Subject: DA 2019/0346 37 Grandview Parade Mona Vale. Submission.

RE: DA 0346/2019 – 37 Grandview Pde, Mona Vale – alterations and additions to dwelling

Image 1 - Existing view of Mona Vale Beach and surf break from ground floor living room and balcony of No. 48 Grandview Pde. Note view corridor of beach between 37 & 39 Grandview Pde

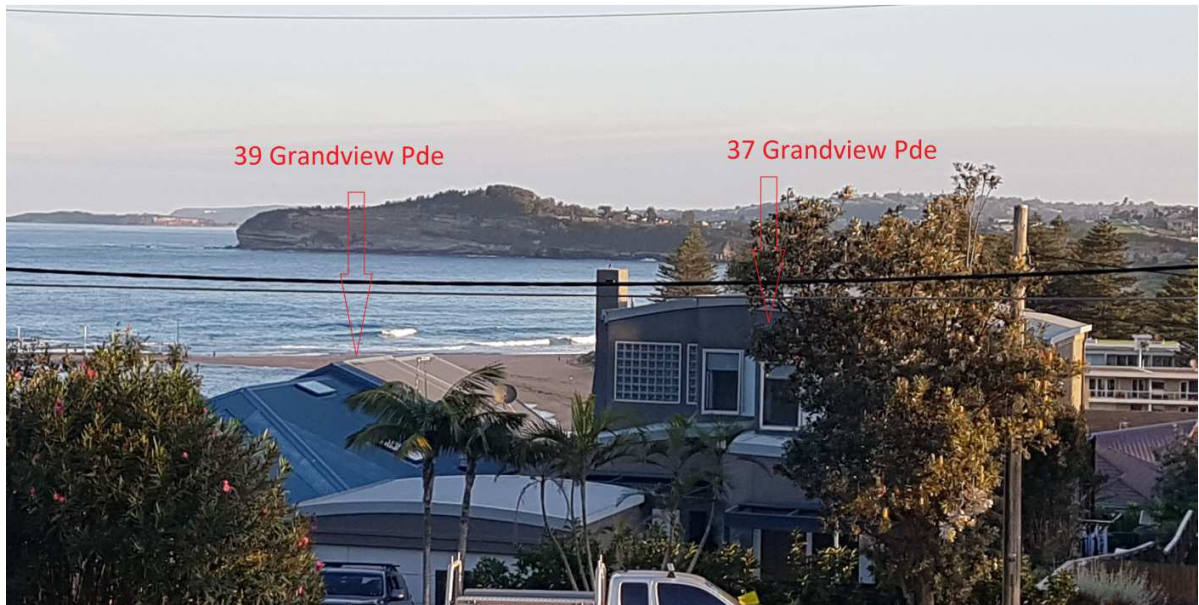
Description of existing view – From No.48 Grandview Parade, local views of the beach and surf break are obtained from the front living room and deck, looking in a southerly direction past and over the north-eastern corner of the existing dwelling at No.37, and over the roof of No.39. Being a local view that is 'dynamic' involving water movement on the shore, waves breaking and surfers riding waves, this is the key element of view interest to No.48. This is demonstrated in **Image 1** over page. Distant static views of Turimetta Head to the south are also noted.

View impact - The proposed additions extend the first storey forward / north to the rear of the existing garage while retaining the existing eave height of the existing first storey. This has the effect of blocking half of the existing view to the beach and surf break from No.48. Refer to **Image 2** below depicting this impact. Clearly this demonstrates that the proposal does not comply with the DCP's view sharing control.
